To provide the engineering requirements for the verification of the "as-built" condition of the Control Rod Drive Scram Discharge Volume Piping System.

QIR NO. (1) 80-627	CALL NO. (2) N/A	DATE (3) 12-12-80
W.A. (SWA) NO. (4) N/A	SUSQUEHANNA S.E.S. X	SYSTEM NAME/NO. (5) Control Rod Hydraulic /55
RESPONSIBLE DEPT/GROUP (6) NPE	ACTIVITY LOCATION (7) Unit 1 React BLDG EL 719	
PROCEDURE TITLE/NO./REV. (8) Control Rod Drive System, Verification PLI-10942 Attachment A		
RIR NO.(S). (9) N/A	NCR NO. (10) N/A	
REASON FOR ACTIVITY (11) Verification of "AS-BUILT" Condition of the CRD Scram Discharge Volume		
INSPECTION DESCRIPTION: (12) Pipi

The following dwgs. differ from the as-built configuration as indicated:

440700-255-1134-23(1)-1

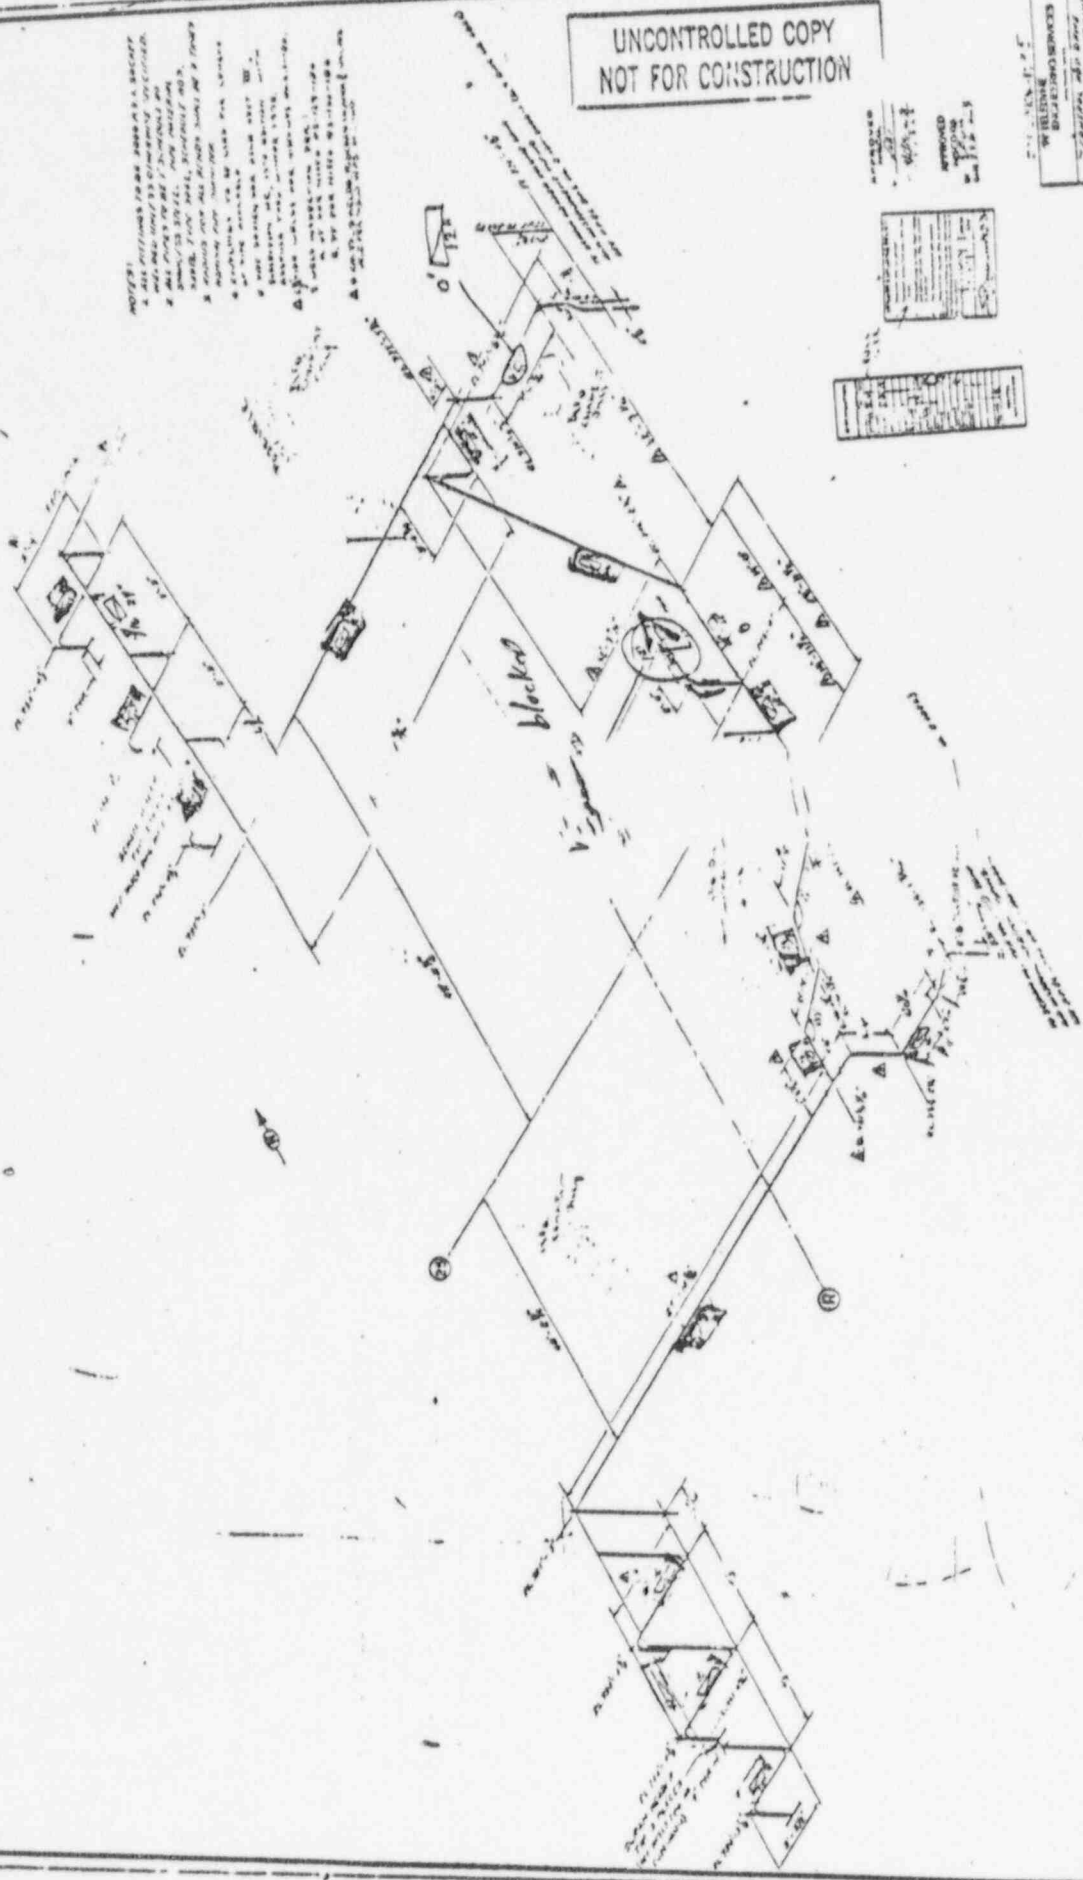
- 3856-M-164-83-(6)-1 Rev NC

The 1" EBB line between valve F092C and F092D has a 0" slope; dwg. indicates 1/8" slope /12"

The line between the scram discharge instrument volume and valve F103 has a 0" slope; dwg. indicates 1/8" slope /12"

Four capped lines, each with 2 valves, are installed in the instrumentation lines of the hydraulic control units on both North and South sides of the containment. The dwg. does not indicated these lines and valves.

A 1" line is upstream of instrumentation lines; dwg. indicates a 2" line.

FILE	VENT FROM XV-1FO10 TO REACTOR SUMP	ALIAS NO. 8856	INSTRUMENT NO. SP-HED-1131-2	REV. 0
------	---------------------------------------	-------------------	---------------------------------	-----------

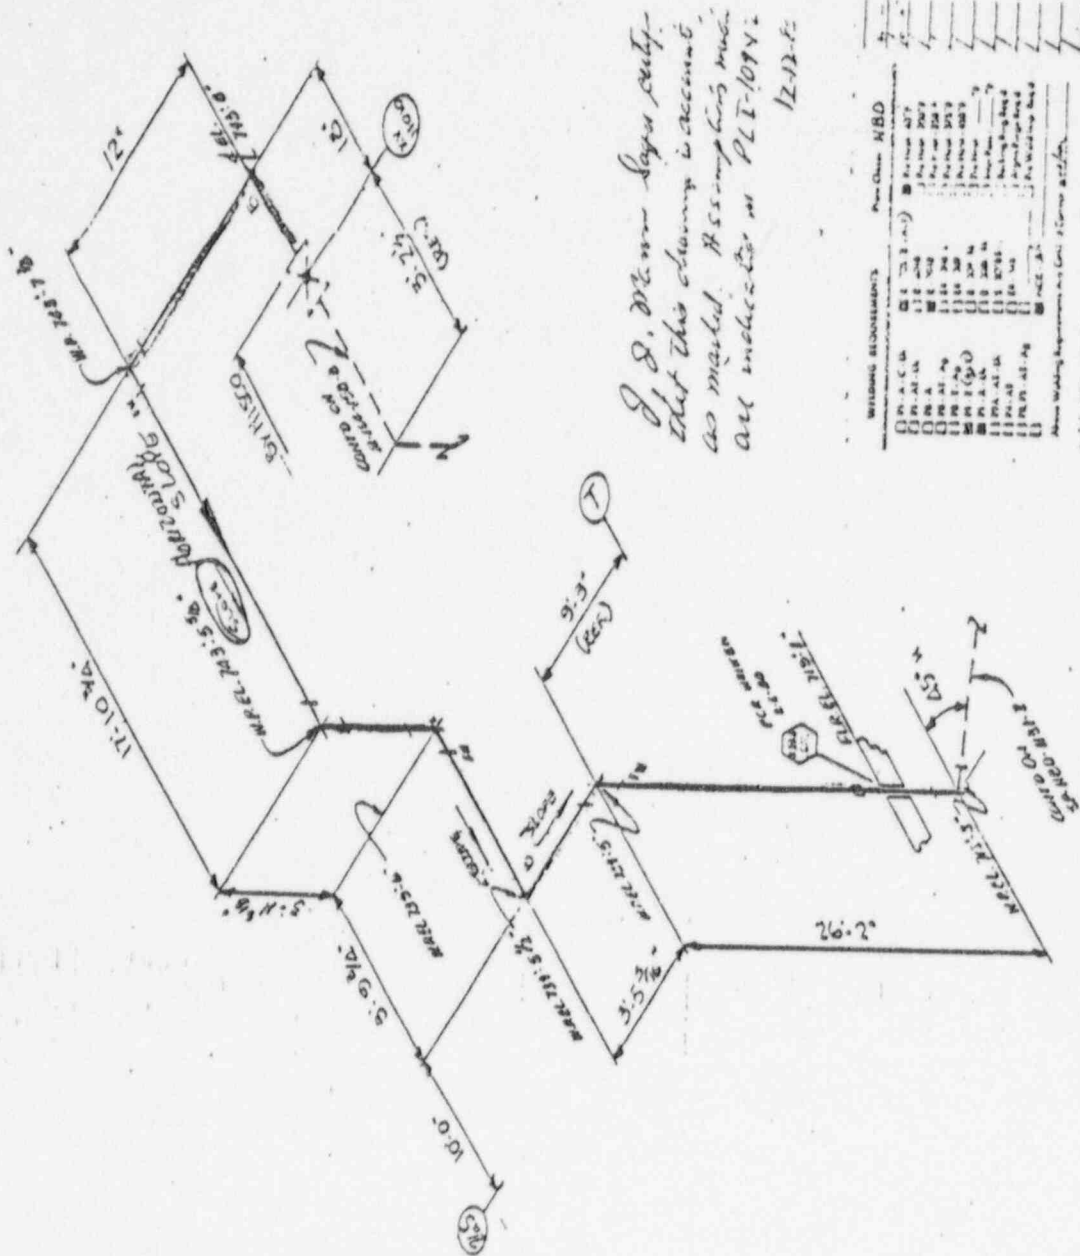
An abnormal condition of valve F010 (ref. dwg. 8856-M-164-158-5  
Rev 3) was found during inspection. The valve is physically  
blocked in the open position by a piece of metal against the  
valve operator. It was noted by PP&L Construction Engineer that  
NISCO had the valve blocked open to maintain a flow path for
